Attachment 1 – Staff Verification of the Vertical Anisotropy to the HJ Horizon Lost Creek, Wyoming

Attachment 1 Figure 1-1

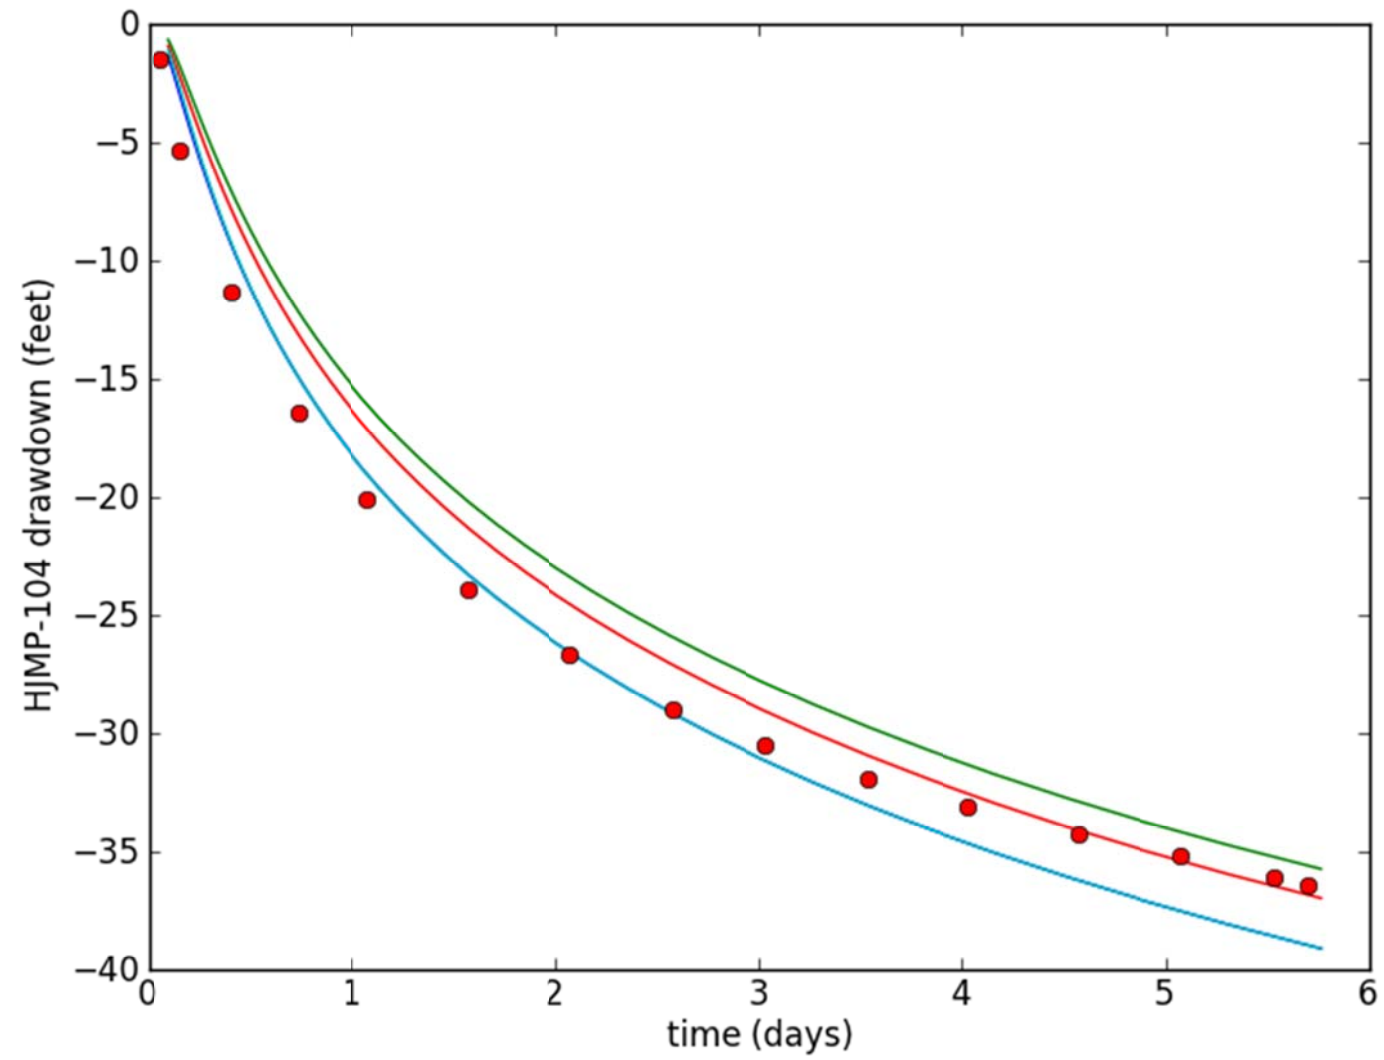
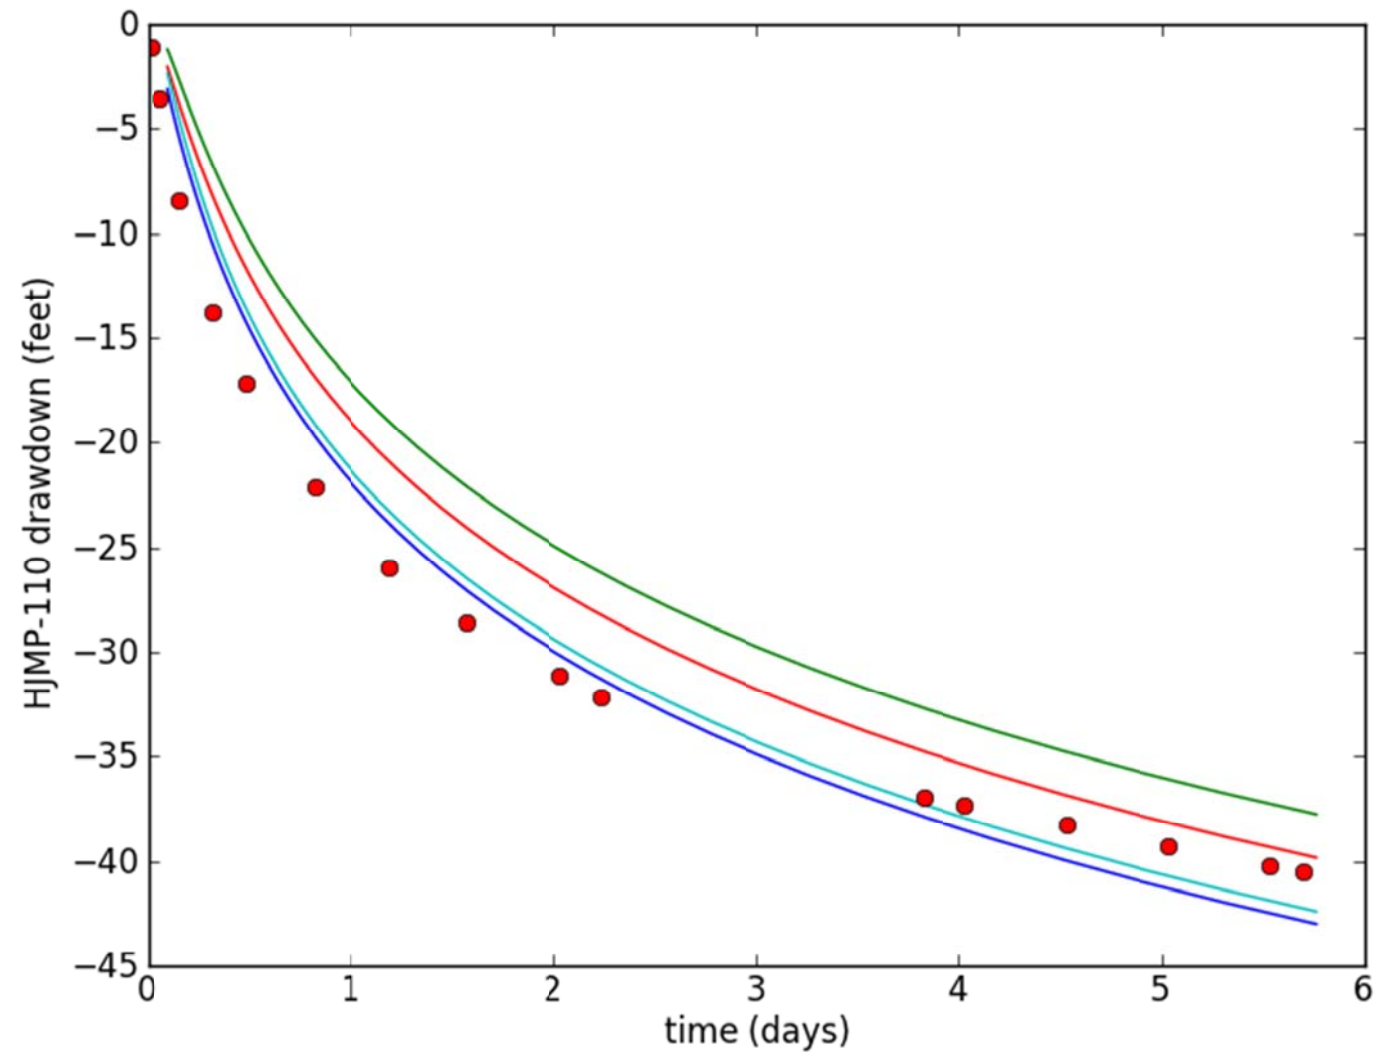
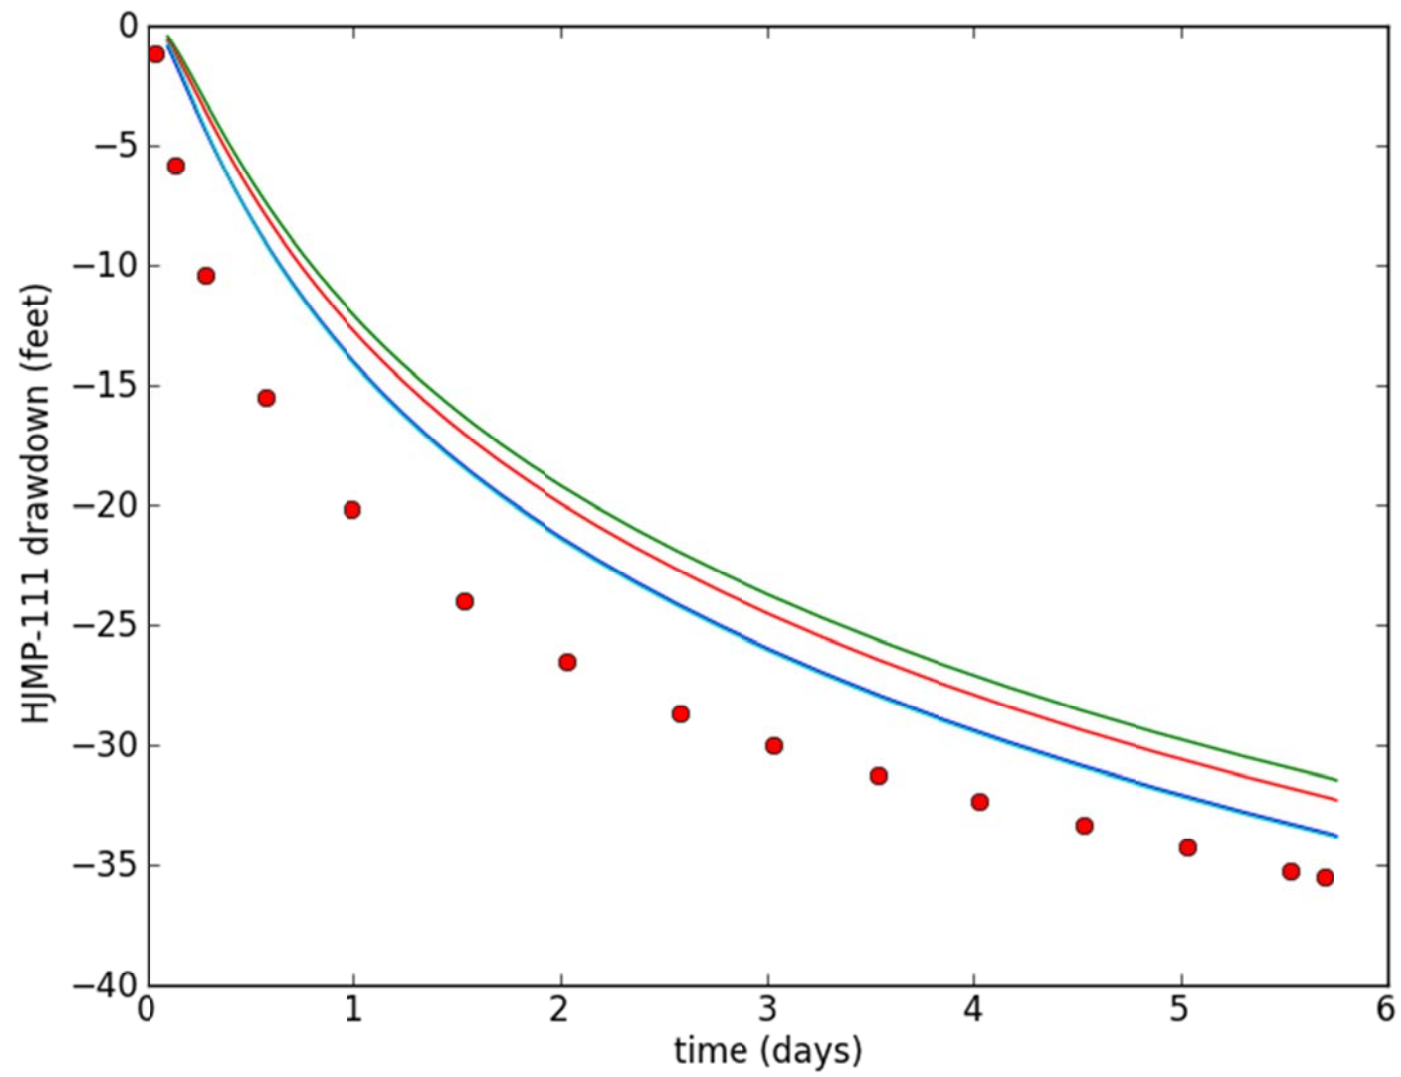
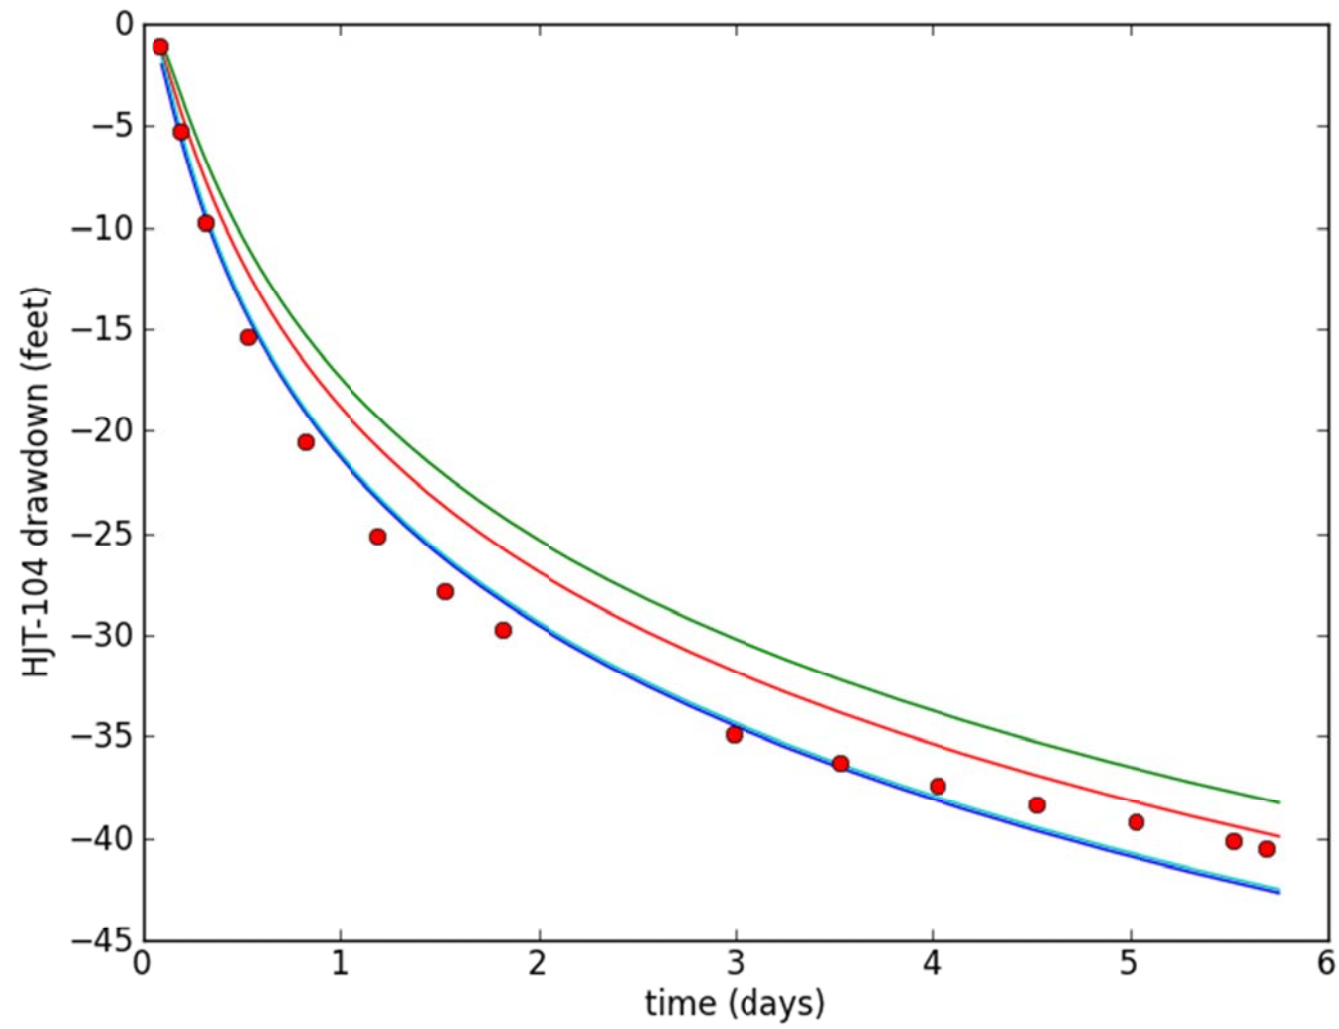
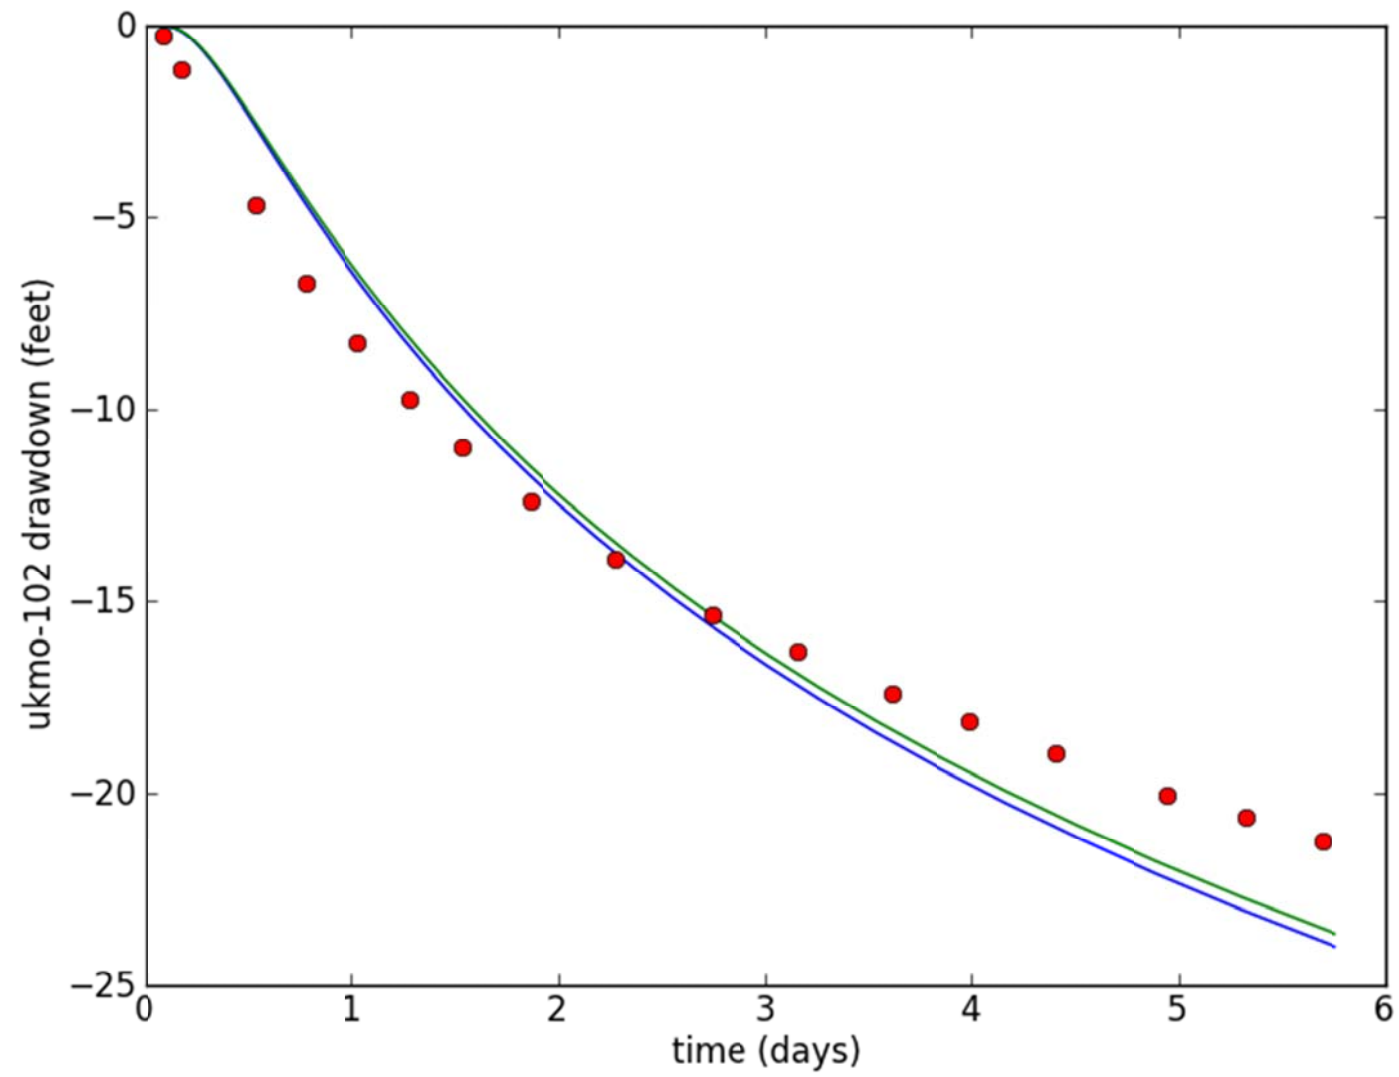
The observed data and model predicted potentiometric heads in zones 1 through 4 at the location of the October 2007 LC19M Pumping Test observation wells are shown on Attachment Figures 1-1 through 1-5. In those figures, the red circles reflect observed data; the green line is the model predicted potentiometric head in Zone 1; the red line is the model predicted potentiometric head in Zone 2; the cyan line is the model predicted potentiometric head in Zone 3; and, the purple line is the model predicted potentiometric head in Zone 4.

Drawdown in Zone 1 was consistently less than drawdown in Zone 3 or Zone 4. The differences in drawdown between each zone vary spatially and temporally. The differences are interpreted as vertical anisotropy to the HJ Horizon. Such anisotropy is consistent with, and supports staff's early calculations for, and explanation of, the apparent anisotropy reported in

Attachment 1 Figure 1-8 Contour of Model-Predicted Potentiometric Head Isopleths along Cross-Section

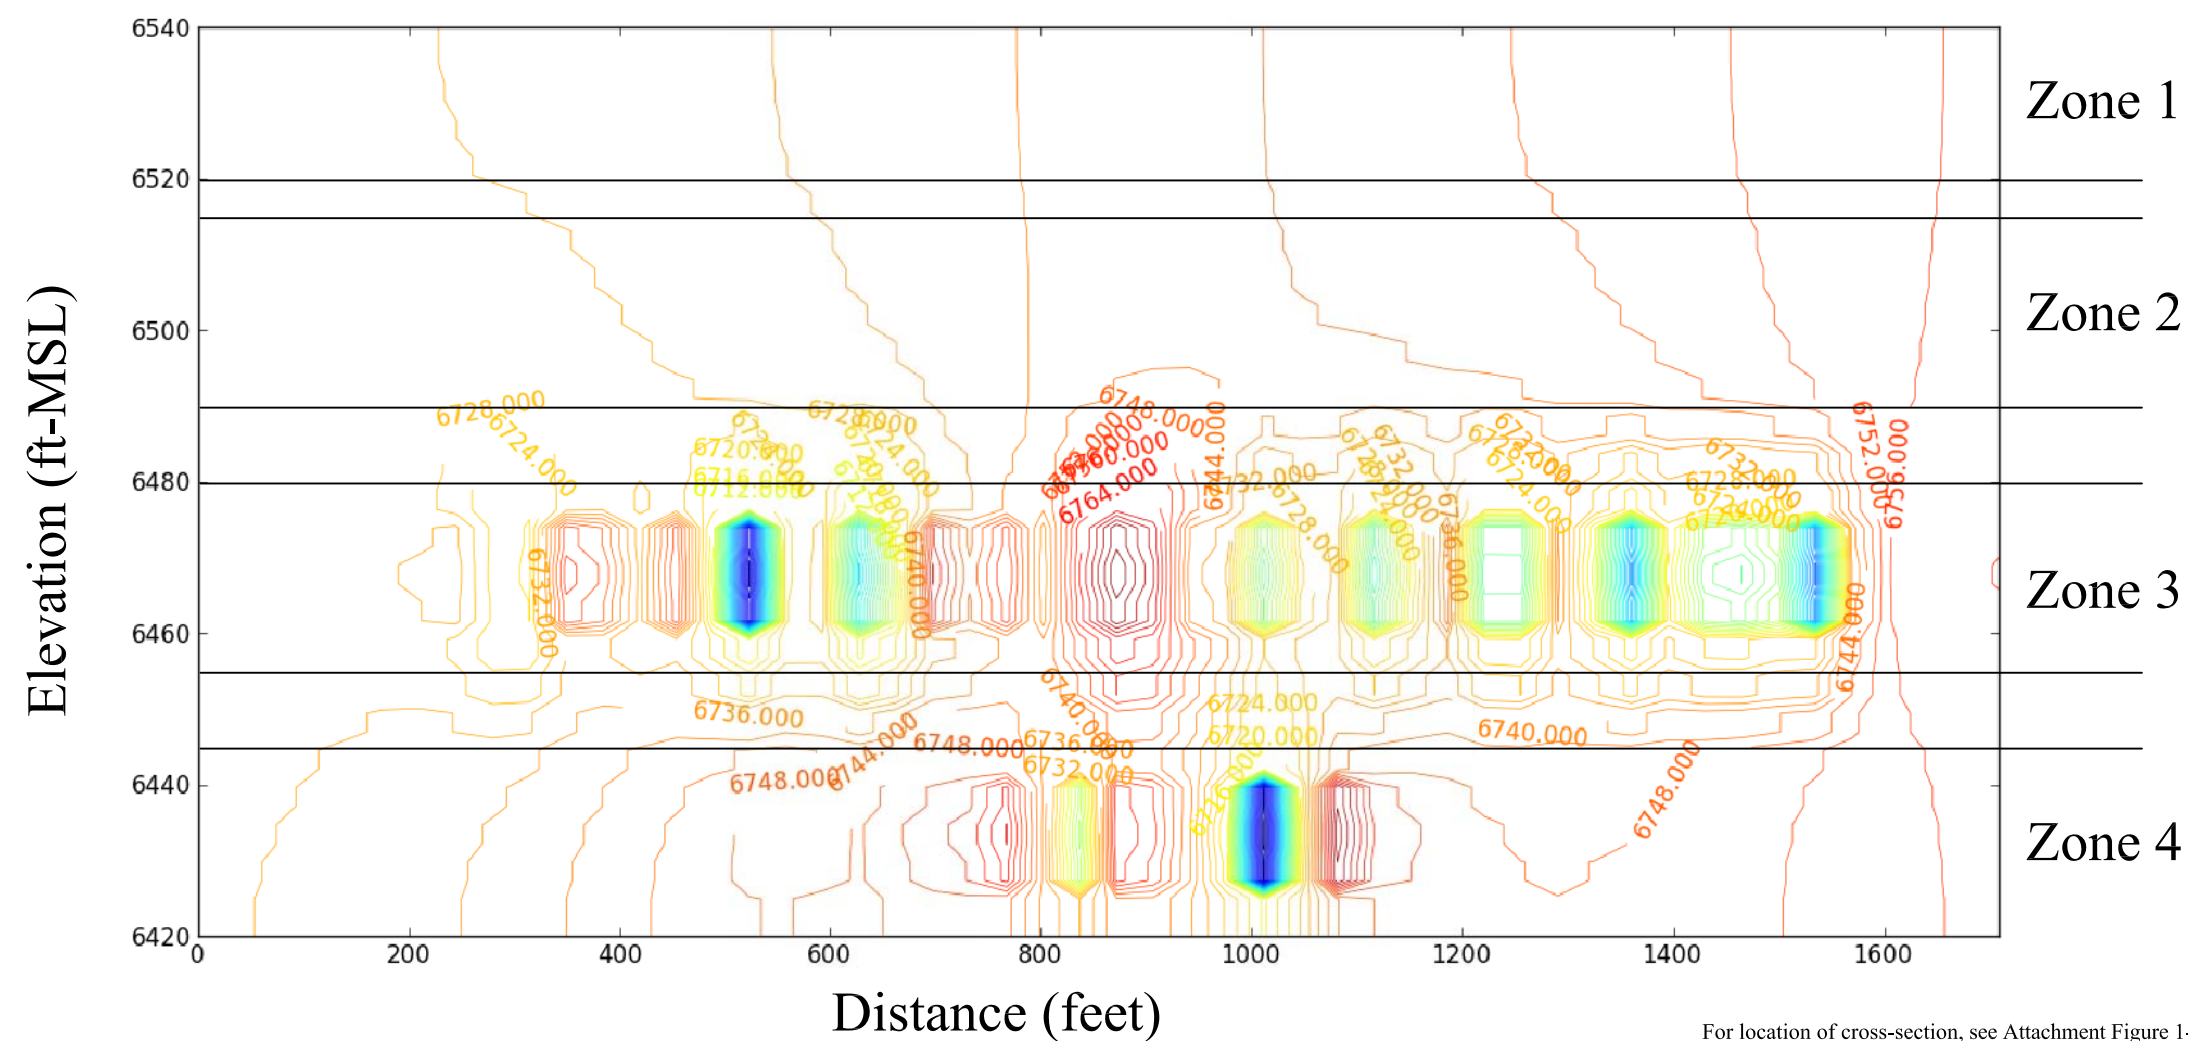
The horizontal line shown on Attachment Figure 1-6 is the location of a vertical cross-section. The model-predicted potentiometric heads along that cross-section are shown on Attachment 1 Figure 1-8. The potentiometric heads indicate that under normal operations, lixiviant migration will be limited to Zones 3 and 4, the zones of operation.
